CERTIFICATE OF APPROPRIATENESS PLACARD

Address OAKWOOD Historic District Historic Property 110-14-MW

605 N BLOODWORTH ST

Raleigh Historic Development Commission – Certificate of Appropriateness (COA) Application

605 N. BLOODWORTH ST. RALEIGH NC 27604

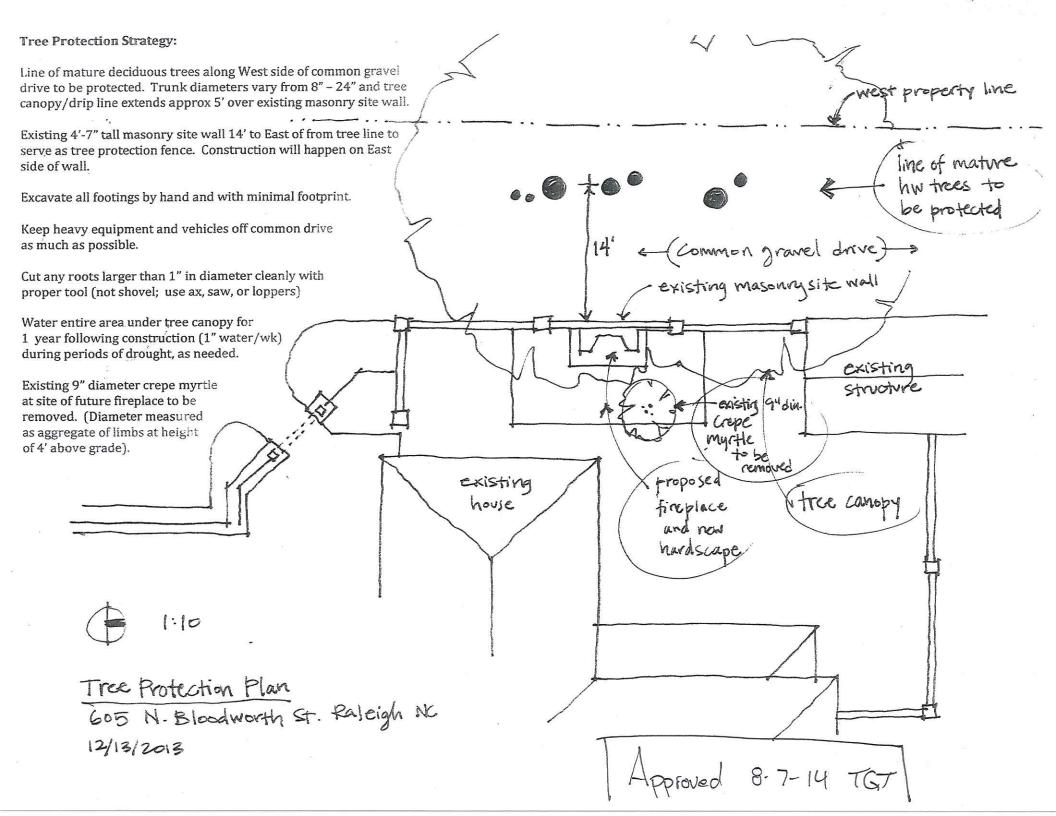
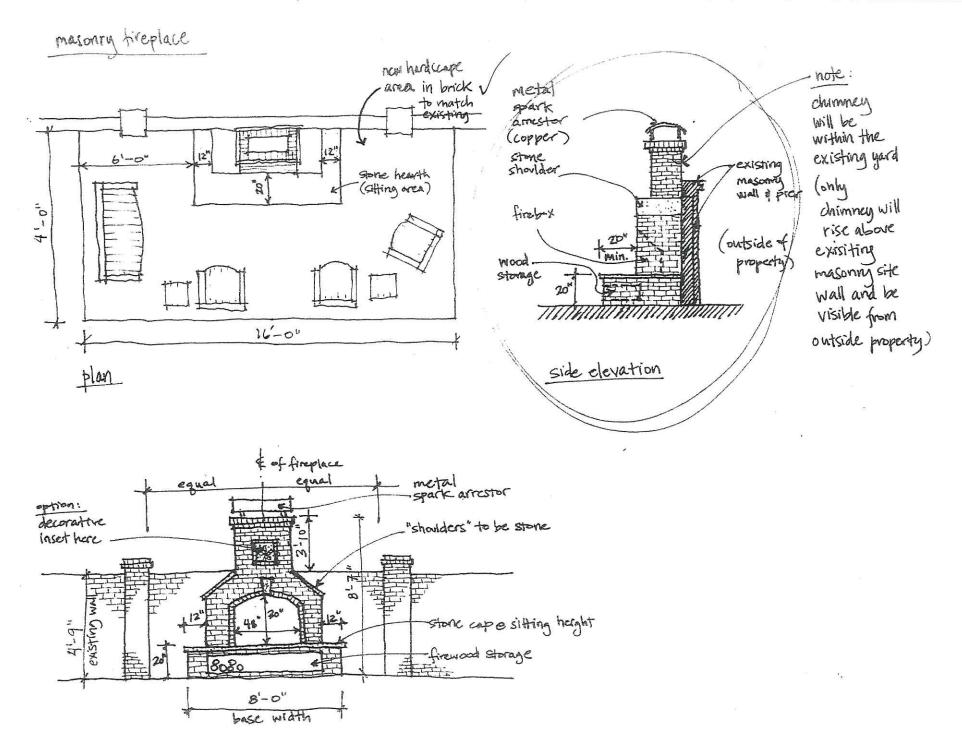
- Specifications for the motion light on the arbor
- Also, there are notes on the plans for uplights. Is this the case? If so, these may not be approvable
